Coupling Attenuation

SPE-I link segment

Status coupling attenuation D 2.1

146.7.1.5 Coupling attenuation

Table 146–6—Coupling attenuation

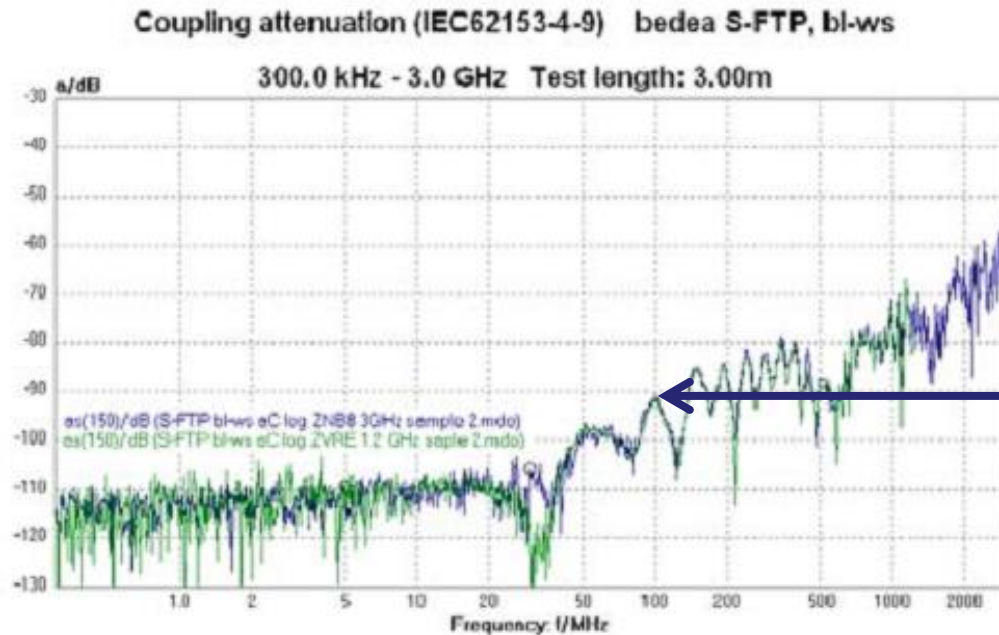
-
- The values in actual table 146-7 are the limits at 100 MHz (as in 802.3bp). The frequency dependency is not shown.
 - The slope towards lower frequencies is confirmed to be 20 dB/decade (as it is for higher frequencies).
 - Example of the formula: $50-20\log(f/100)$ with a measurement plateau of 85 dB.

Replace table 146-7 by:

| Frequency (MHz) | (dB) | | |
| | E_1 | E_2 | E_3 |
| 0,1 to 20 | $40 - 20\lg(f/100)$ | $50 - 20\lg(f/100)$ | $60 - 20\lg(f/100)$ |
| Values greater than 85 shall revert to 85 | | | |
